**US 13B & MD 513 (CEDAR LANE)  
 (FRUITLAND, MD)**

REVISION "E"

RED LINE I TEDD APPROVAL *Jeff Mandel* 7/19/06

| TRAFFIC SIGNAL PLAN |                     |                             |  |

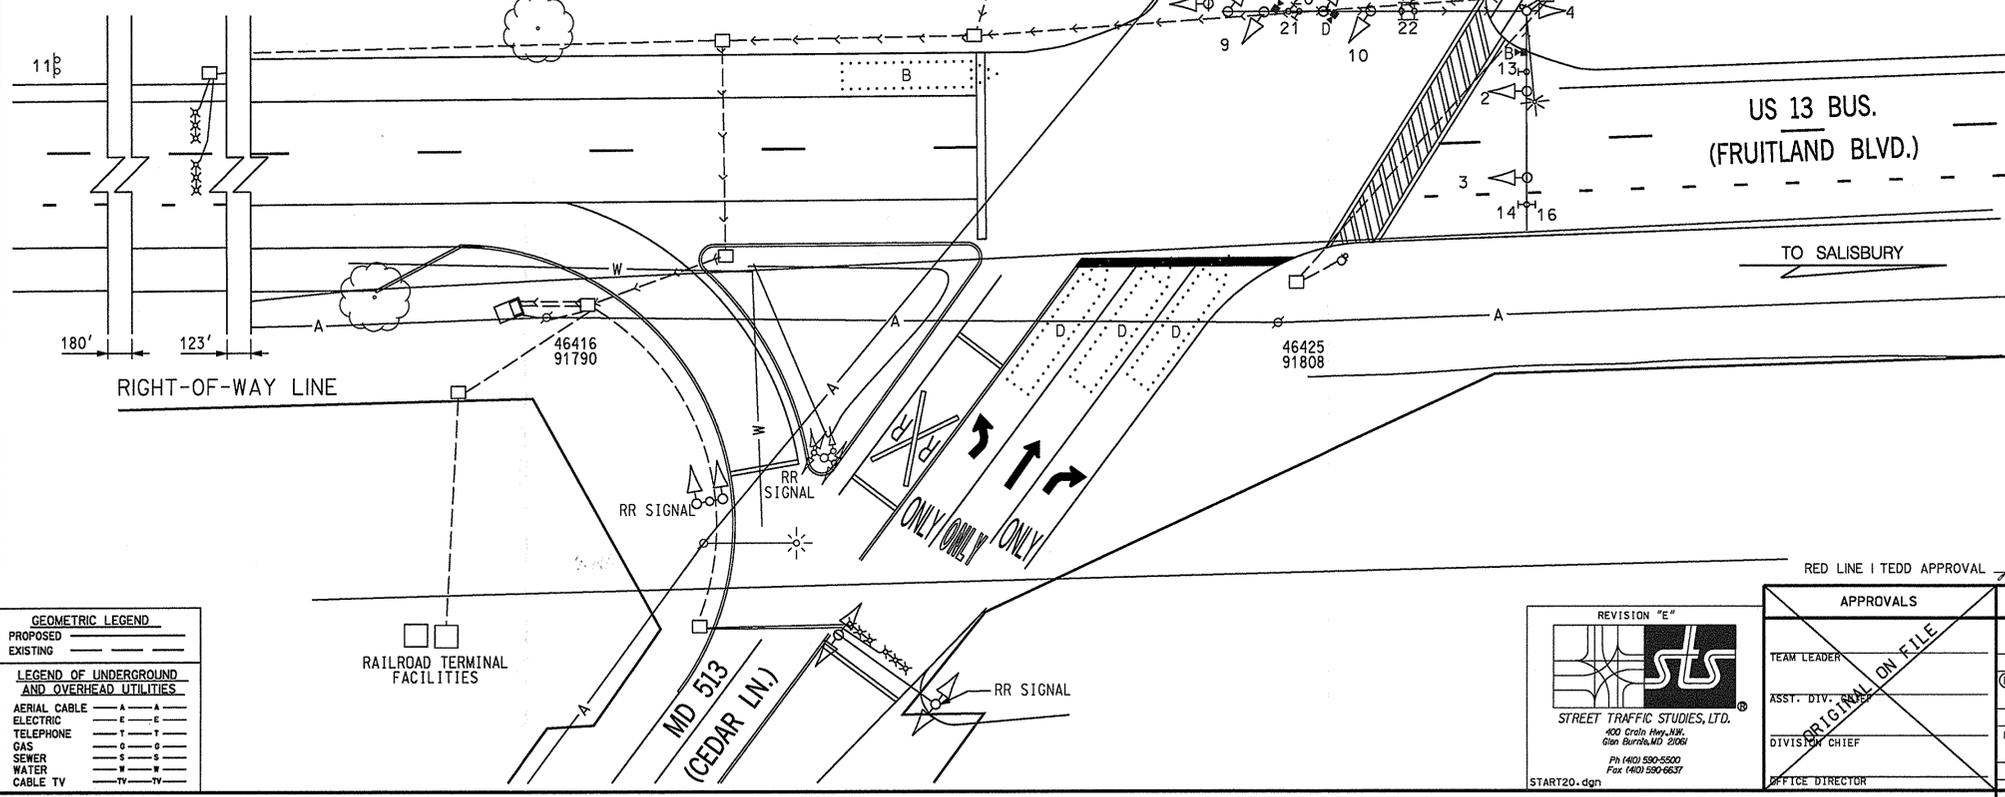
| APPROVALS        | REVISIONS   |
|------------------|---|
| ASST. DIV. CHIEF | ⑤ INSTALL REDLINE VIDEO DETECTION 6/06<br>SHA*ATT25185                  |
